THE BRAUN CORPORATION
"Providing Access to the World"

Re: Recall of Braun manufactured handicapped accessible mobility vehicles
Ref. NHTSA Campaign Number:

Safety Recall Notice Service Bulletin 36144

Trailing Arm Inspection and Reinforcement
Plate Retrofit Instructions
Applicable for 2005-2008 GM Entervan®
Lowered Floor Conversions

Trailing Arm
Inspect this Weld

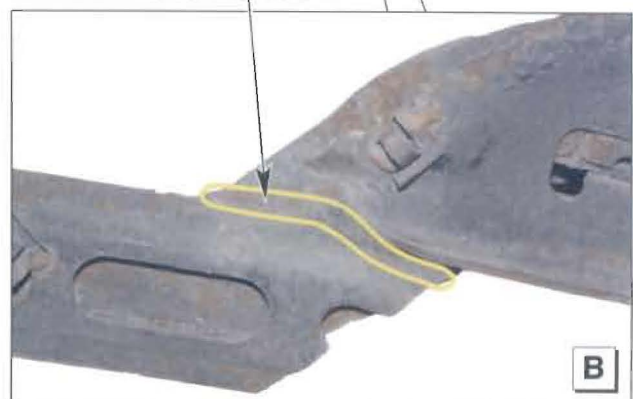
1. Remove rear wheel.
2. Inspect trailing arm weld identified in Photos A and B. Remove debris and undercoating from weld area.

Ensure the presence of the weld and verify the weld is free of cracks.

If the weld is present and free of cracks, no further action is required. Apply undercoating and install rear wheel.

If the weld is missing or cracked proceed to Step 3.

Weld Highlighted in Yellow

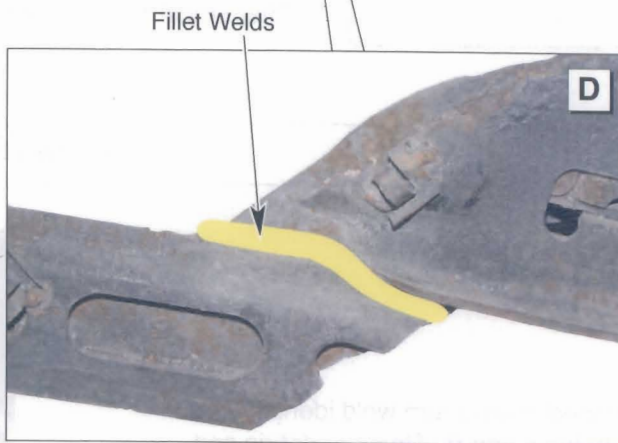
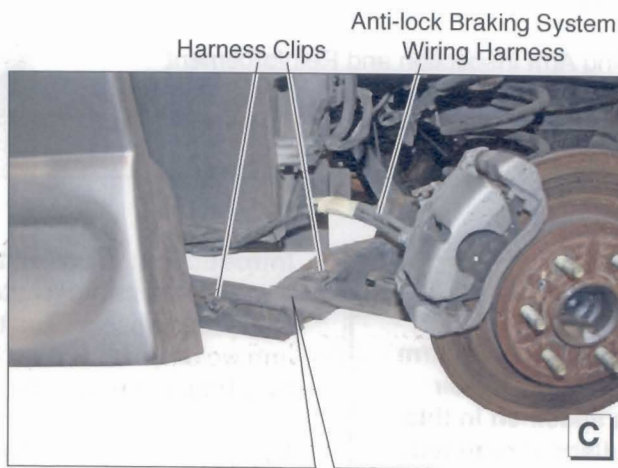
4. Remove anti-lock braking system wiring harness from securement clips and secure harness clear of the trailing arm. See Photo C.

Remove under coating and seam sealer from the weld areas. Remove questionable weld(s). Ensure surfaces to be welded are free of weld slag and grinding debris.

5. Apply penetrating fillet welds along the edges of brackets as shown in Photo D.

Inside of
Trailing Arm

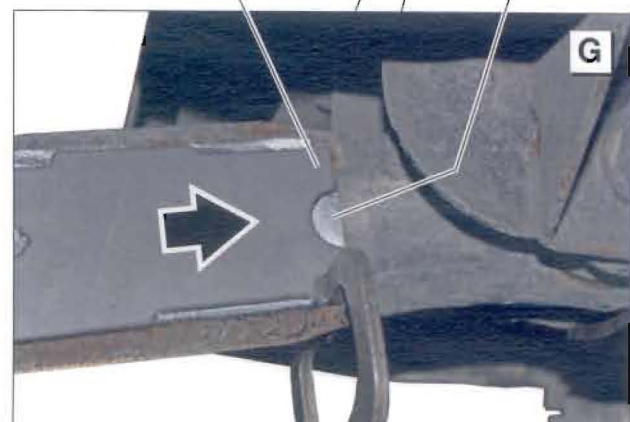
6. Clean surface on inside of trailing arm (remove any debris, undercoating, or rust). See Photo E.

7. Center reinforcement plate on inside of trailing arm with the forward end of reinforcement plate flush with forward end of trailing arm. See Photos F and G.

Weld reinforcement plate as shown in Photos H and I on page 4.
